# Access Compliance Report

## Public Rights-of-Way

Intersection ID: 27961	Main Street: DINKINS_COACH_PL	Cross Street: POUND_HILL_LN	Location: NE
ADA ID: 707025A731AA	Ramp Type: BlendTrans1	Initial Pass/Fail: Fail	Overall Compliance: No
		Severity Score: 12.5

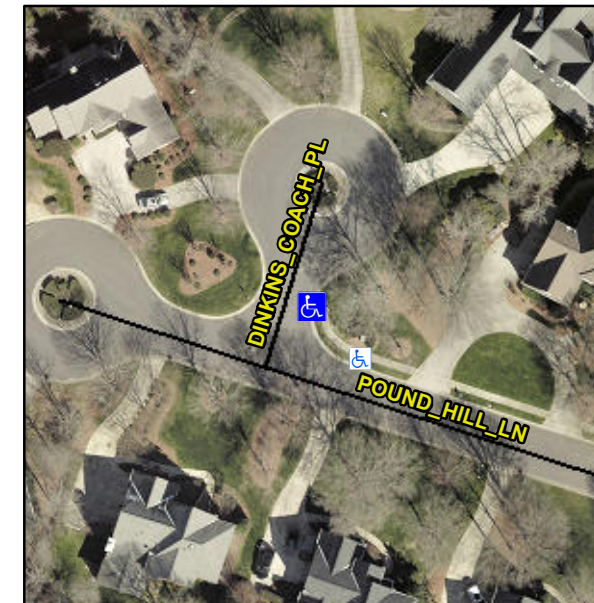
**R304.5.3**

Compliance	Description	Data	Compliance	Description	Data
N/A	Ramp Length (in)	50.0	Yes	BlendTrans Slope (%)	3.8
Yes	Ramp Width (in)	48.0	No	BlendTrans XSlope (%)	6.8
N/A	Flare Type LT	N/A	N/A	Flare Type RT	N/A
N/A	Flare Slope LT (%)	N/A	N/A	Flare Slope RT (%)	N/A
N/A	Flare Traversable LT?	N/A	N/A	Flare Traversable RT?	N/A
N/A	Landing Length (in)	N/A	N/A	DWS Provided?	N/A
N/A	Landing Width (in)	N/A	N/A	DWS Contrast?	N/A
N/A	Landing Slope (%)	N/A	N/A	DWS Length (in)	N/A
N/A	Landing X Slope (%)	N/A	N/A	DWS Full Width?	N/A
N/A	Landing Curb? (Y/N)	N/A	N/A	DWS Offset (in)	N/A
N/A	Shared Landing?	N/A			
N/A	Gutter Ponding?	N/A	N/A	Gutter Slope (%)	N/A
N/A	Gutter Lip Ht (in)	N/A	N/A	Gutter X Slope (%)	N/A
N/A	Painted X Walk1?	No	N/A	Painted X Walk2?	N/A
	X Walk 1 Direction	To NW		X Walk 2 Direction	N/A
	X Walk 1 Width (in)	N/A		X Walk 2 Width (in)	N/A
	X Walk 1 Slope (%)	0.8		X Walk 2 Slope (%)	N/A
	X Walk 1 X Slope (%)	2.7		X Walk 2 X Slope (%)	N/A

**Remove & Replace Curb Ramp With Two New Directional Ramps or Equivalent.**
